PATHFINDER

Re: Docket No. 40-6622, License No. SUA-442

PATHFINDER
 PATHFINDER MINES CORPORATION
 SHIRLEY BASIN, WYOMING T28N, R78W
 LOCATION OF SURFACE
 WATER SAMPLING SITES

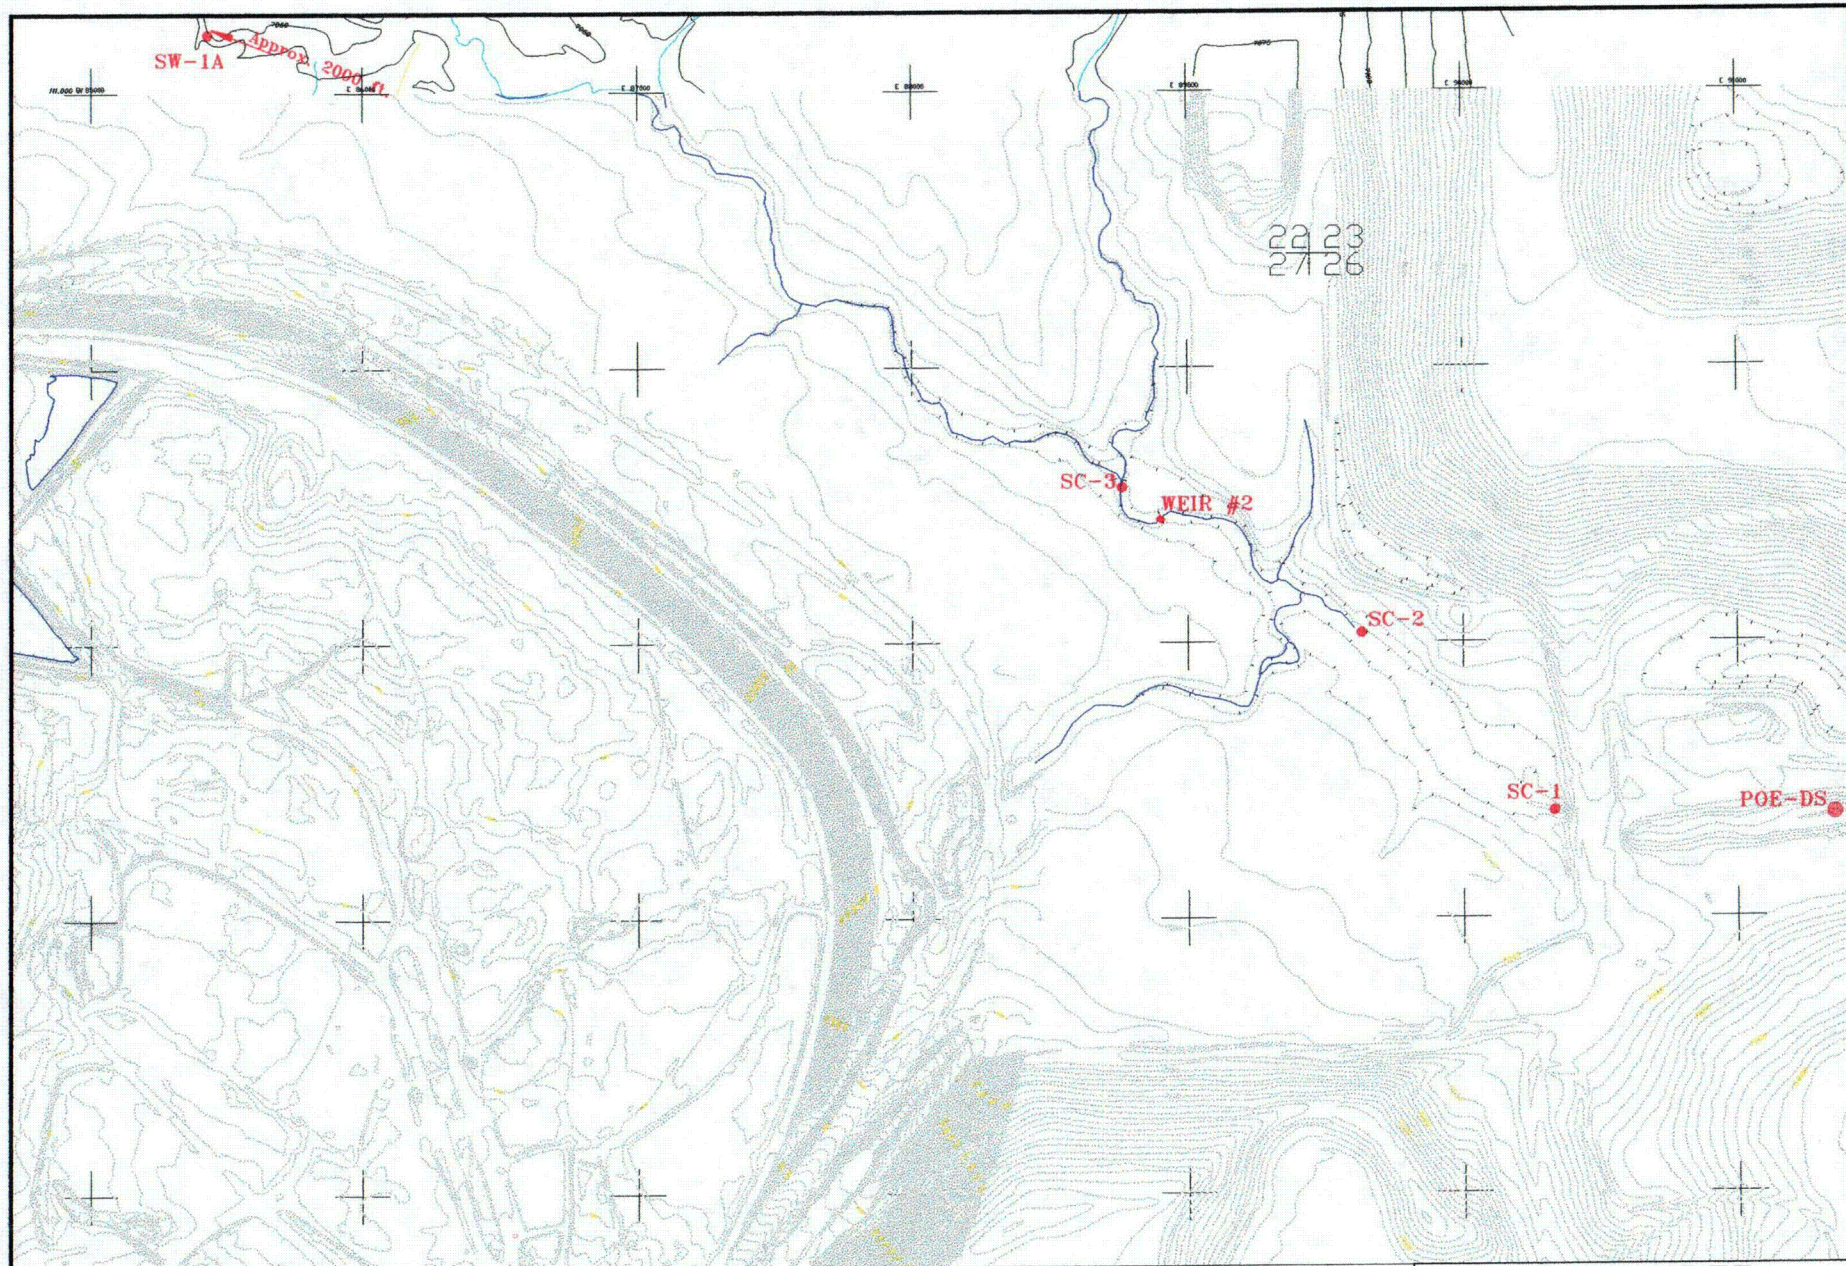
We belatedly discovered a labeling error on the semi-annual ground water monitoring report as required by SUA-442 license condition 47C that we just submitted. Figures 3, 6, 9, 12, 15, 18, and 21 show Spring Creek sample site SC-3. Similarly, Table 3 lists SC-3. Condition 47A specifies sampling site Weir-2. In fact, site Weir-2 (located just downstream from SC-3, see the enclosed map) was sampled. The figures and Table 3 were mislabeled. The error has no impact on the conclusions of the report, and the error will be corrected in the next report. However, if you so desire, we can forward a revised report. Please let me know if you would like the report corrected.
